# Addendum

**Project:** Harris County Psychiatric Center Renovation  
Units 1C, 2E, 3B, 3C, 3D, & 3E

**Addendum No.:** 002

**Date:** November 14, 2016

**A10.02**

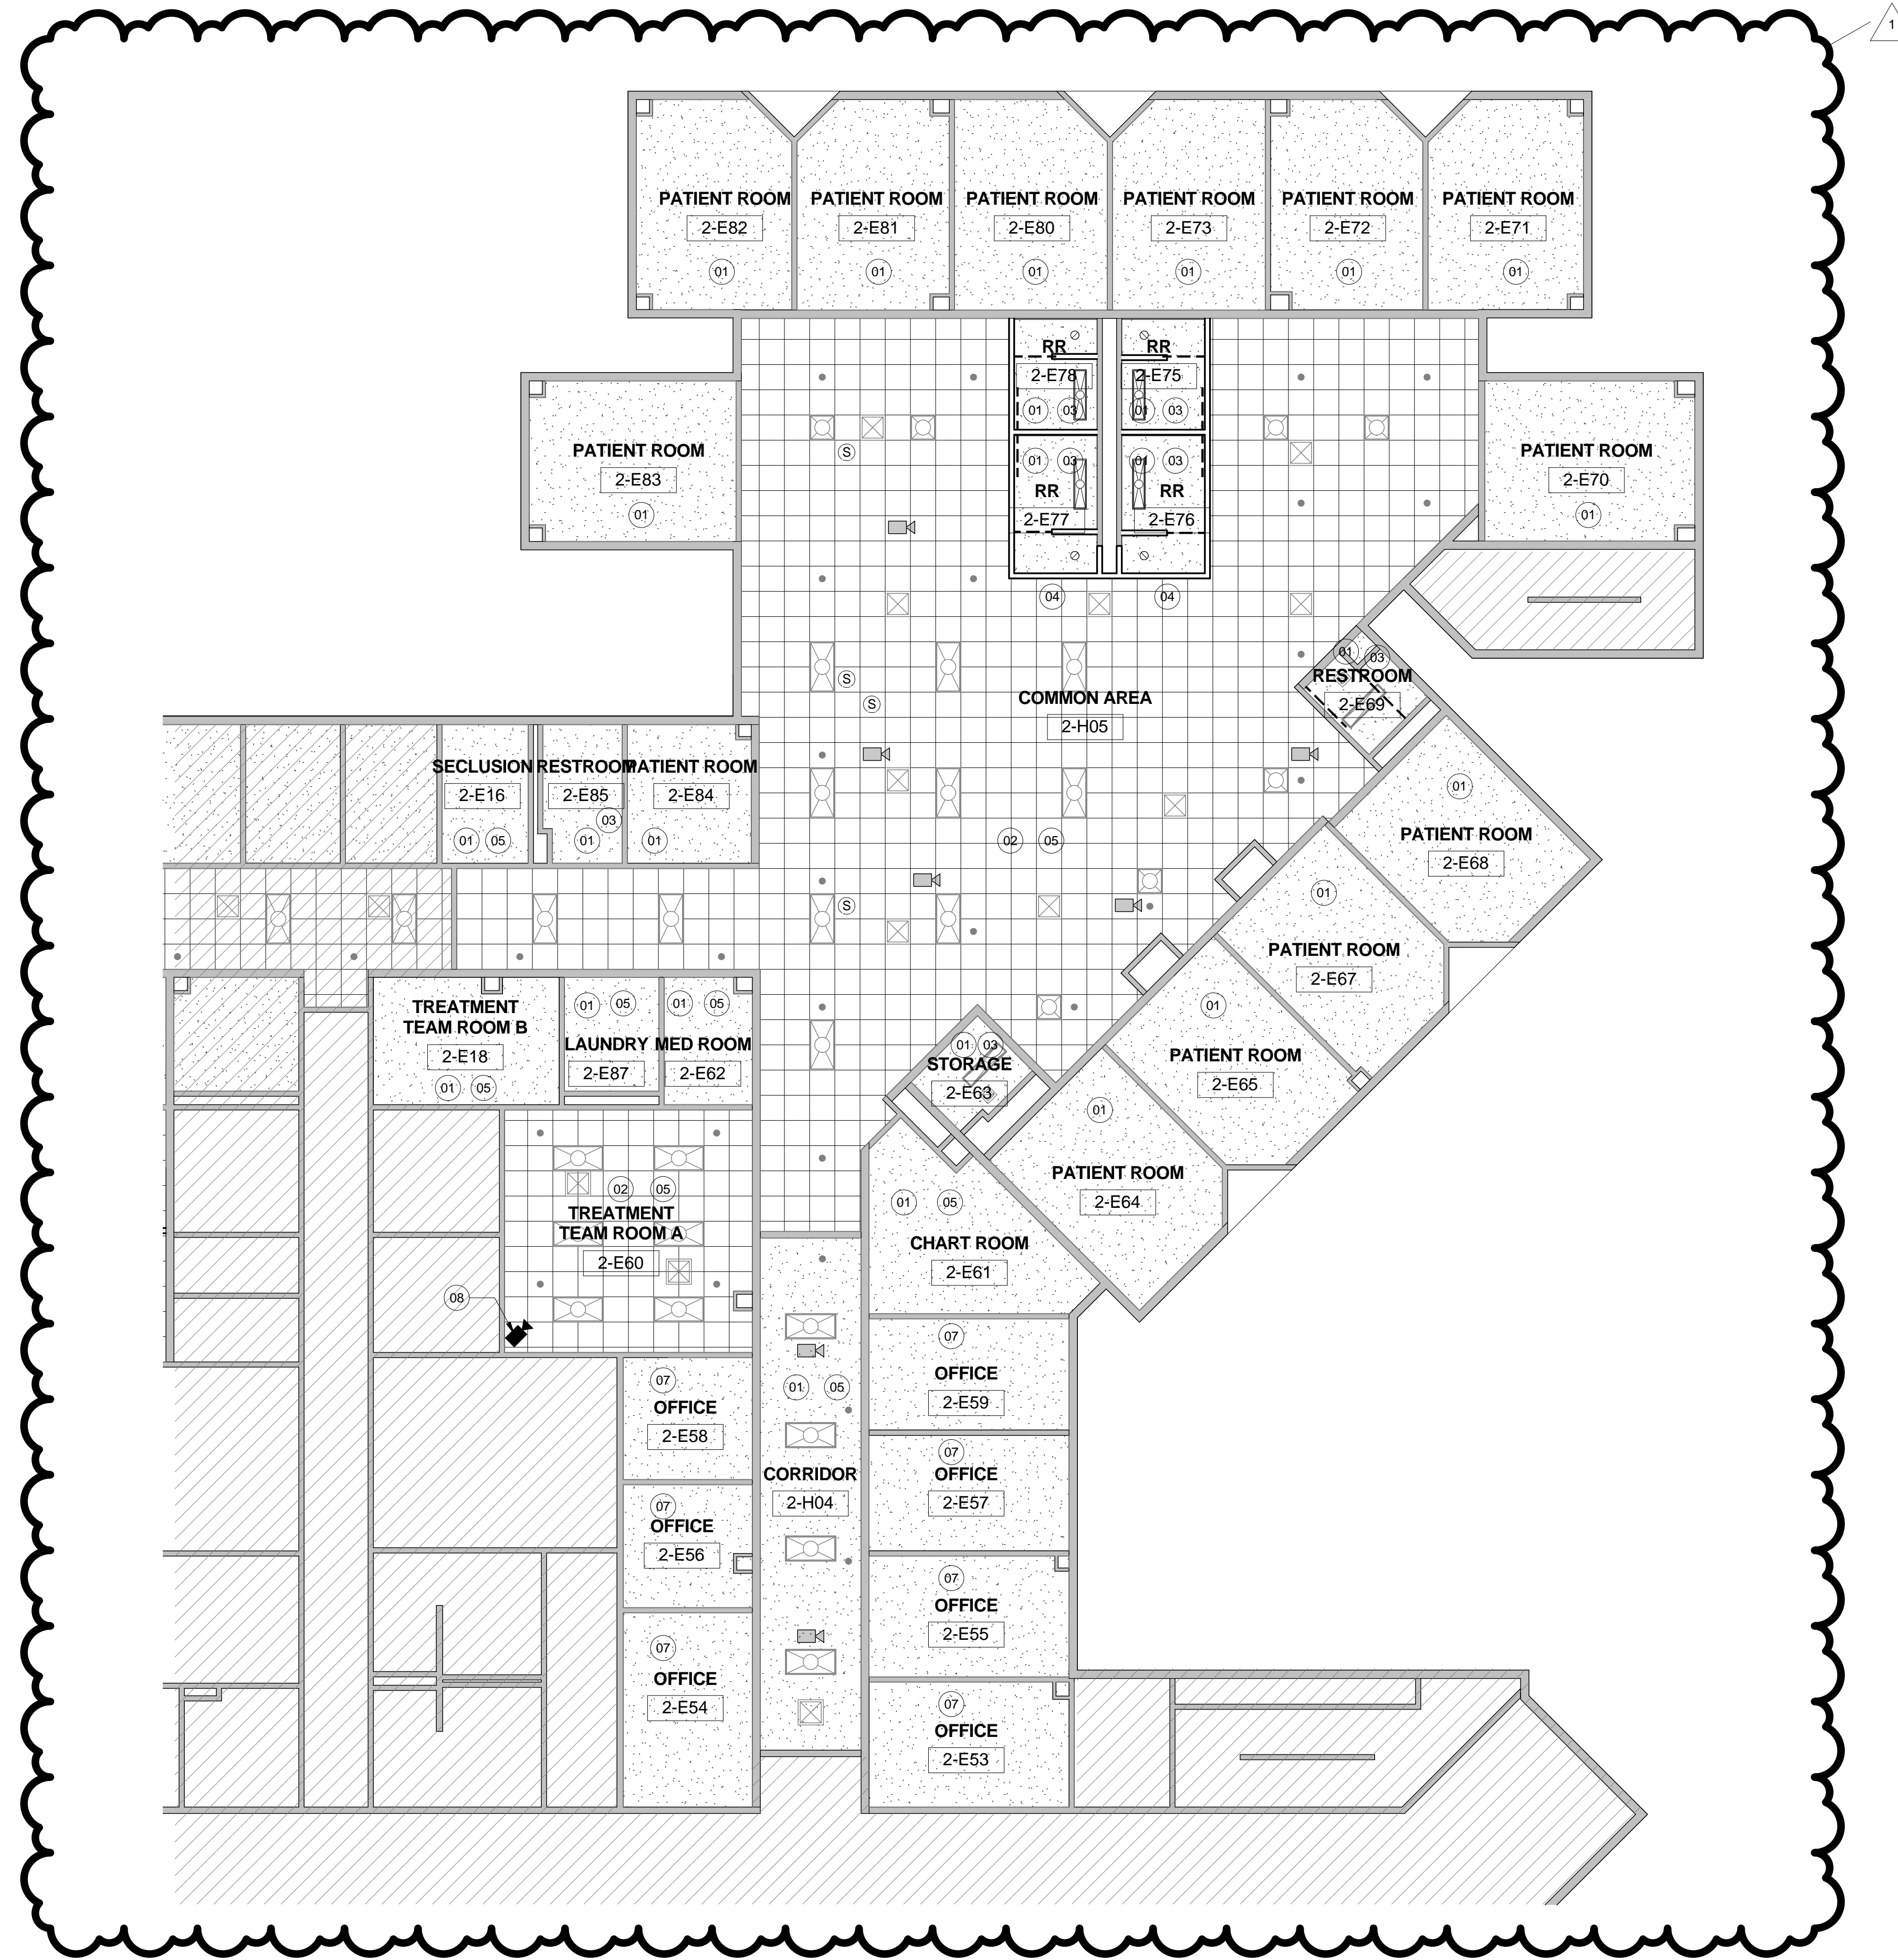
16. Sheet A10.02, Reflected Ceiling Plan – Unit 2E Second Floor, revised to reflect changes to keyed note text and placement on the reflected ceiling plan in order to provide additional clarification regarding the scope of work pertaining to existing and new light fixtures throughout the unit. (see attached)

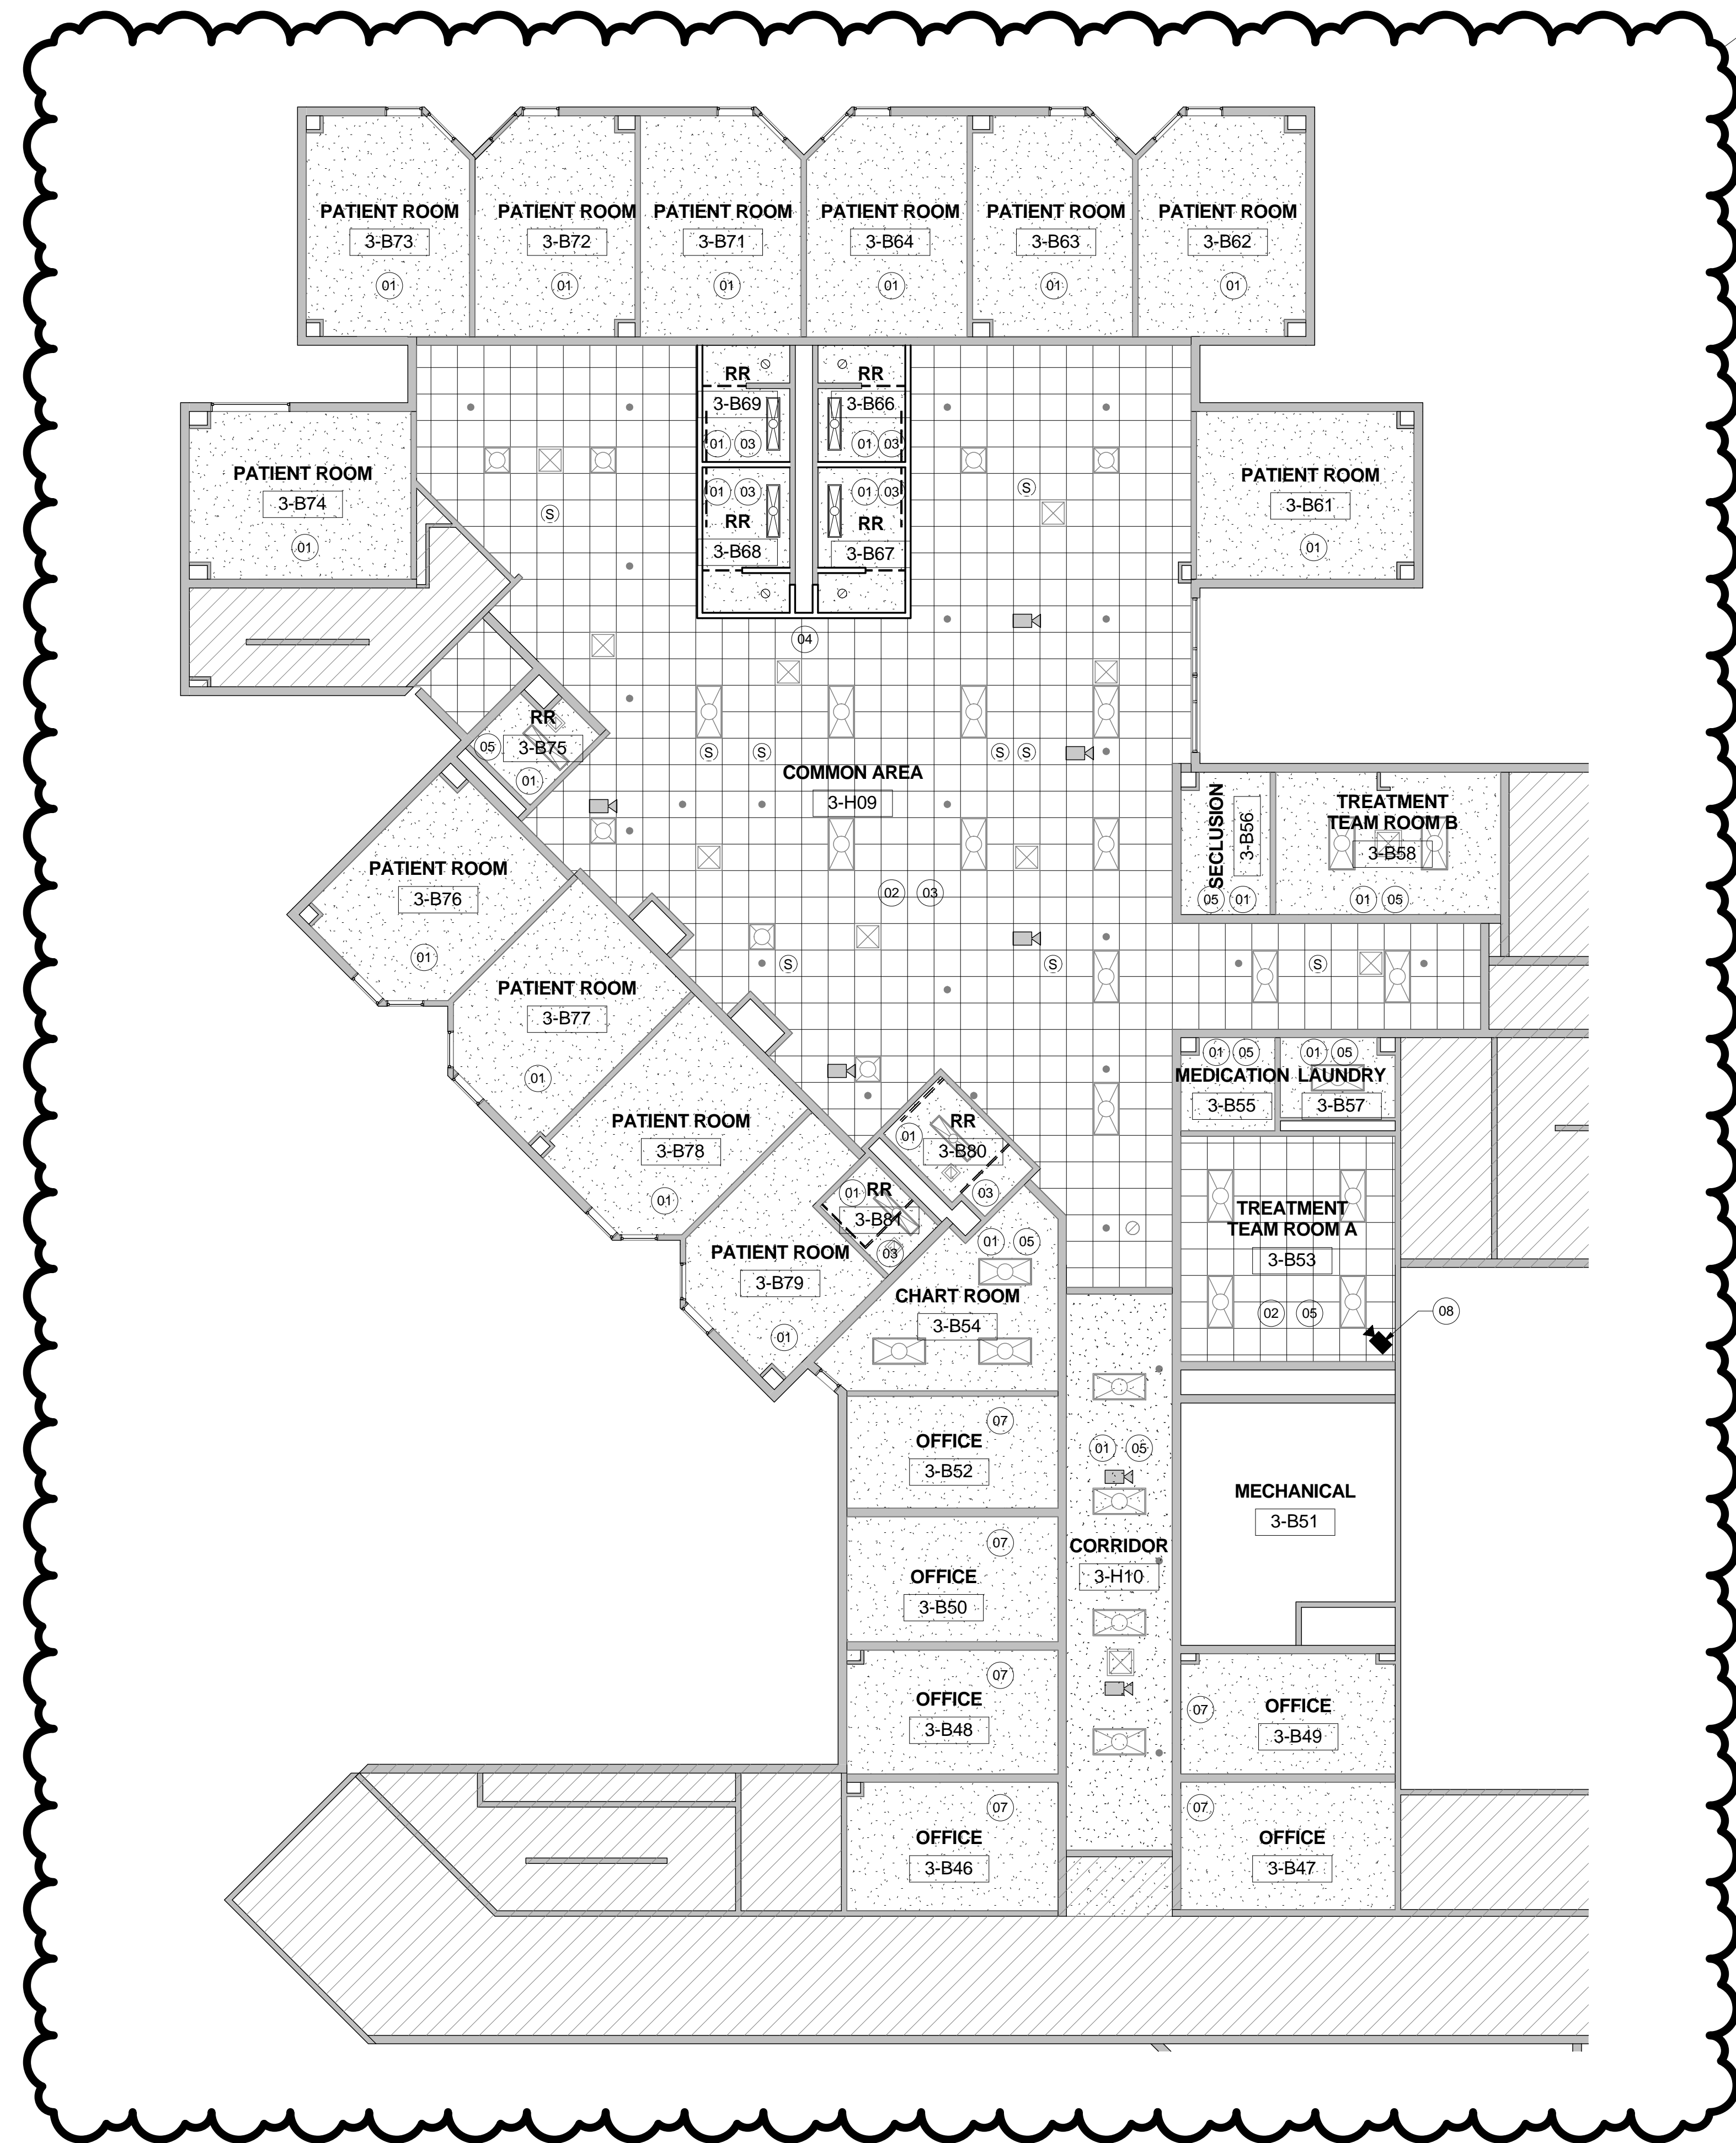
17. Sheet A10.03, Reflected Ceiling Plan – Unit 3B Third Floor, revised to reflect changes to keyed note text and placement on the reflected ceiling plan in order to provide additional clarification regarding the scope of work pertaining to existing and new light fixtures throughout the unit. (see attached)

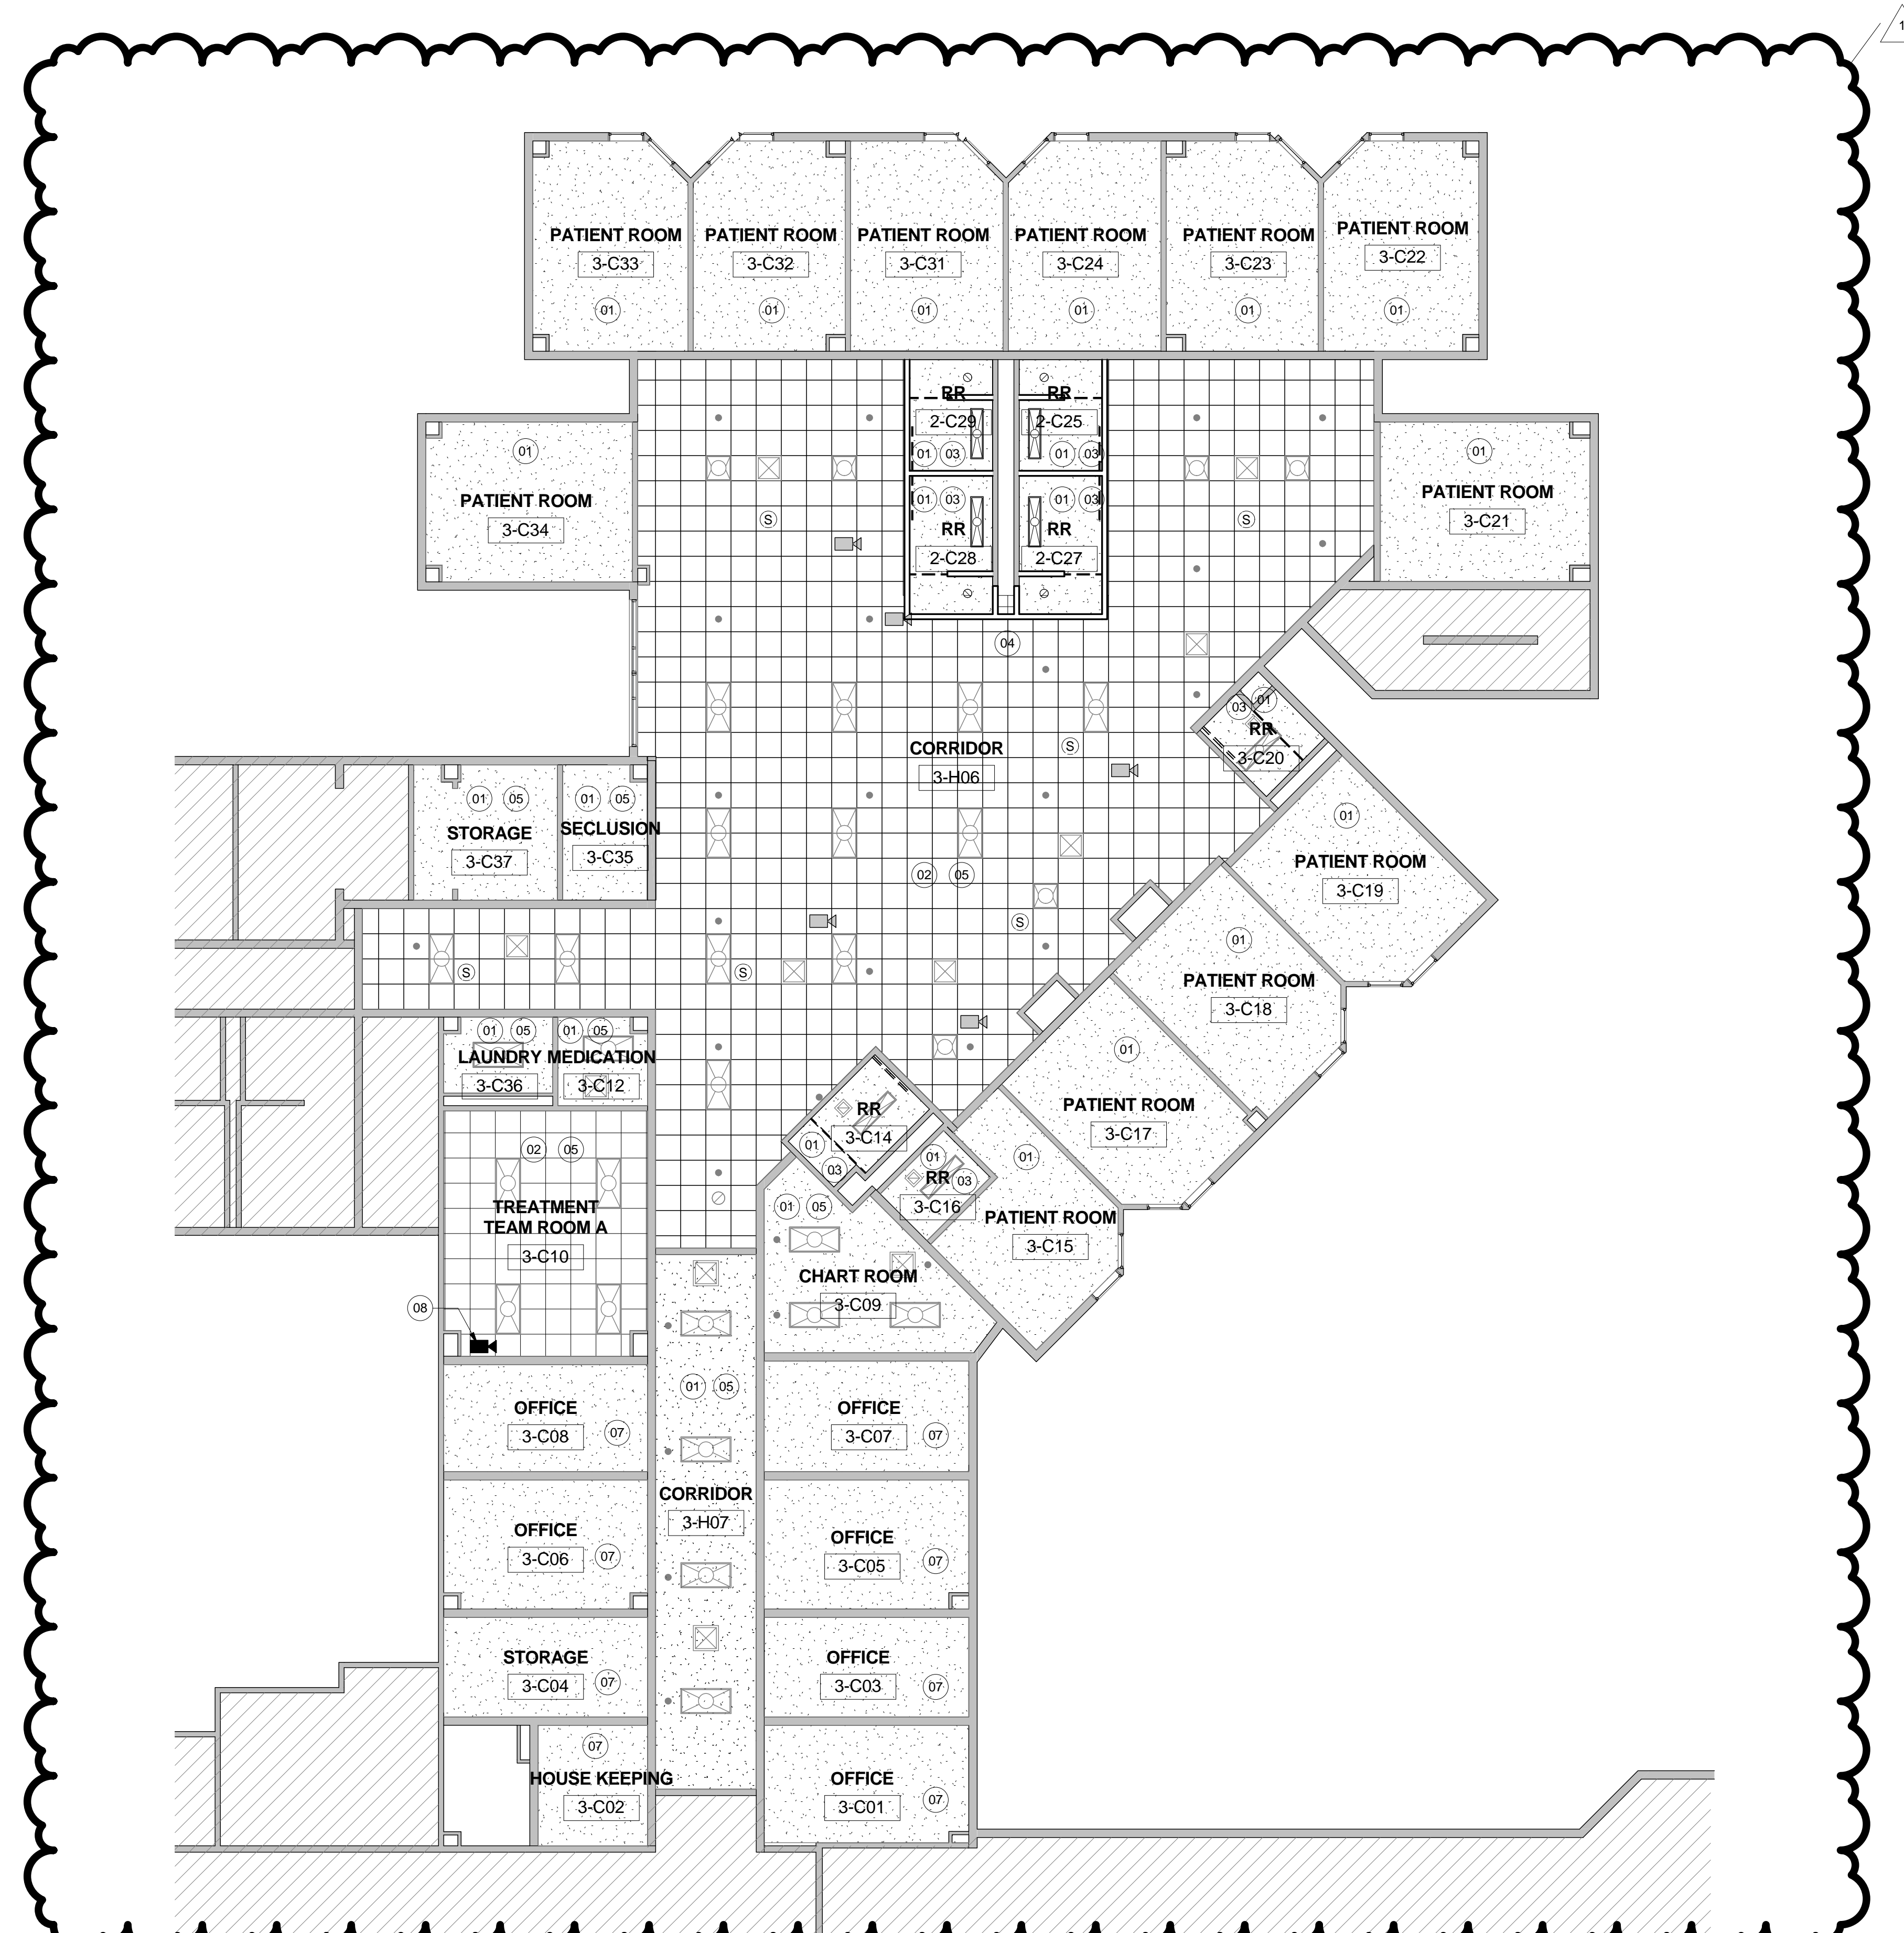
18. Sheet A10.04, Reflected Ceiling Plan – Unit 3C Third Floor, revised to reflect changes to keyed note text and placement on the reflected ceiling plan in order to provide additional clarification regarding the scope of work pertaining to existing and new light fixtures throughout the unit. (see attached)
